**Generic Design Assessment – New Civil Reactor Build**  
**Step 4 Fault Studies – Containment and Severe Accident Assessment of the**  
**EDF and AREVA UK EPR™ Reactor**

Assessment Report: ONR-GDA-AR-11-020b  
Revision 1  
January 2014

**Figure 2:** Outline View of the Reactor Pit

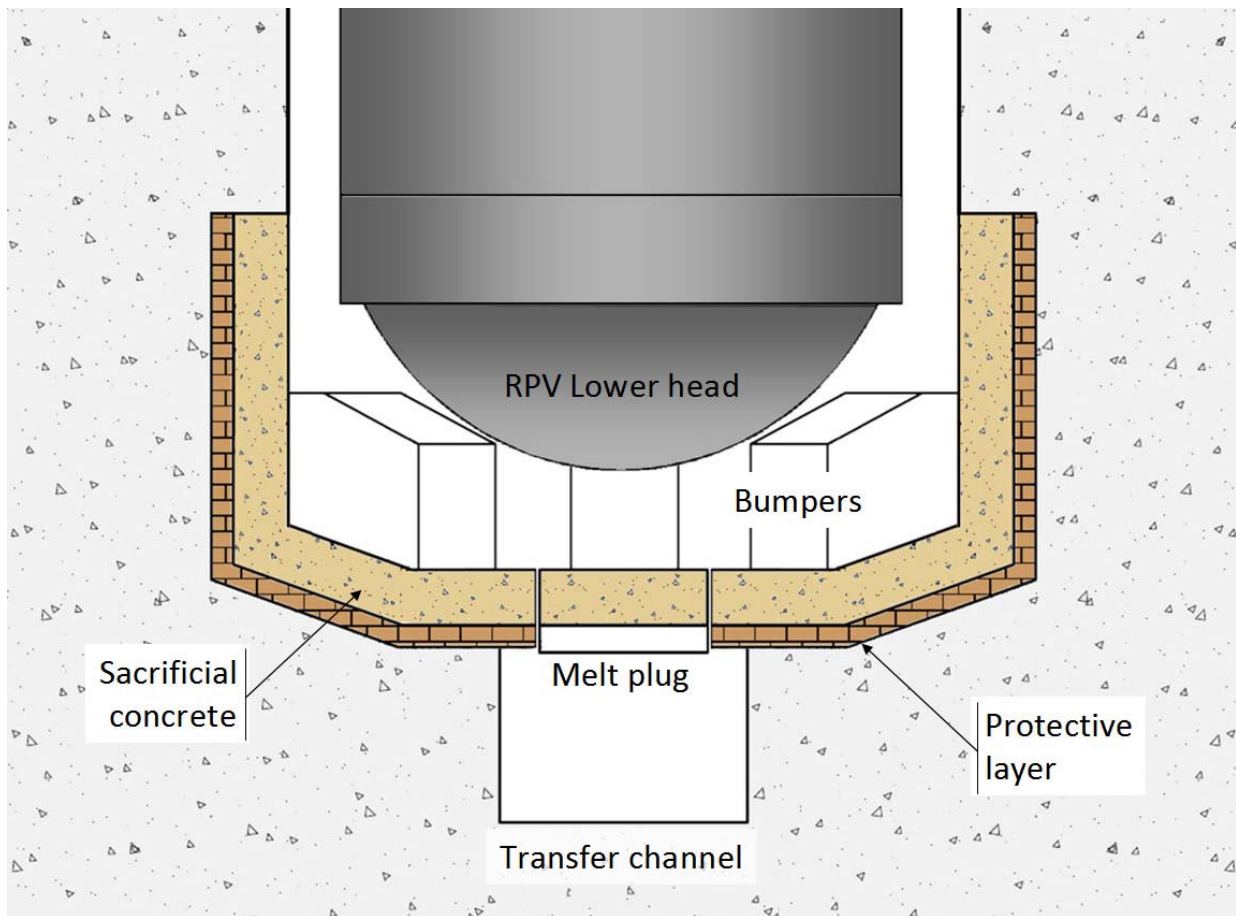
155 The reactor pit design is intended to accommodate and retain the volume of molten material that may be available for relocation from the RPV. The reactor pit is illustrated in Figure 2. The lower surfaces within the reactor pit are covered by sacrificial concrete laid above protective ceramic layers. I have considered the total amount of corium that could accumulate within the RPV lower head and how this relates to the height of the protective ceramic layer in the reactor pit. The concern here related to the potential failure level of the RPV that may be higher than the height of the sacrificial concrete and protective layer.

156 In response to an enquiry (TQ-EPR-1060, Ref. 9) EDF and AREVA have provided information relating to the likely height that the RPV will fail at due to the two competing phenomena; relocation of corium within the RPV, and RPV wall creep failure. The combination of thermal, chemical composition and structural effects is claimed to influence the creep failure, and the timing of the failure will influence the quantity of the corium being relocated into lower head and hence the associated location of the RPV wall failure.

157 I recognise that the RPV failure is an energetic event, combining significant quantities of core melt at high temperature, and the failure phenomena and supporting analysis to predict the melt behaviour are complex. I thus consider the timing and precise RPV failure dynamics contain uncertainties that are dependent on accident scenarios, assumptions and simplifications associated with the modelling capturing the key phenomena. I accept the response to TQ-EPR-1060.

**Figure 3:** Schematic View of the Transfer Channel and the Spreading Area

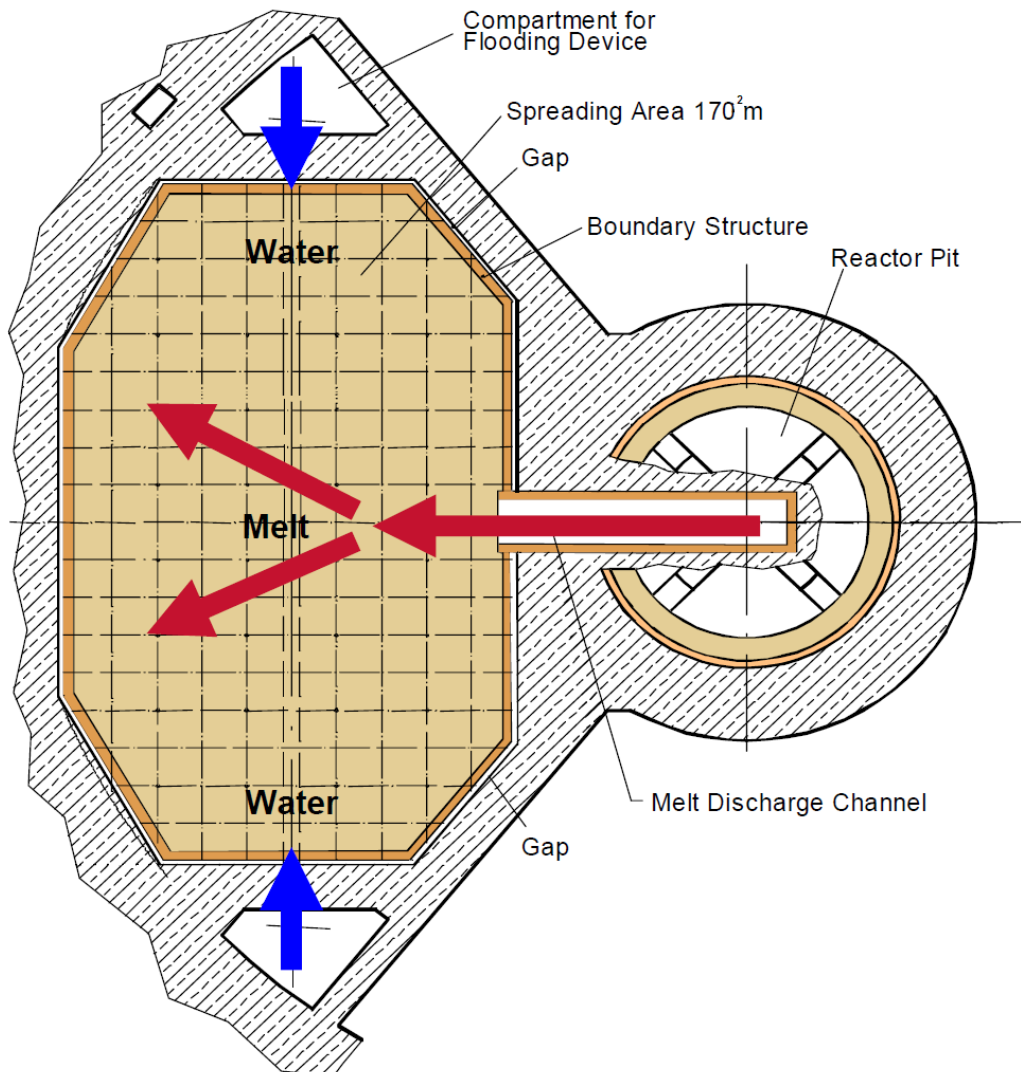
- 226 The floor, ceiling and sidewalls of the transfer channel are covered by layers of zirconia ( $ZrO_2$ ) and coated steel. The schematic view of this feature is illustrated in Figure 3. In this channel, the governing interactions between corium and zirconia are different to those within the reactor pit such that:

- 230 In summary, I consider that the interaction between zirconia and residual corium in the transfer channel has been examined within the safety submission and the depth of the

residual corium will allow re-solidification without any significant degradation of the zirconia.
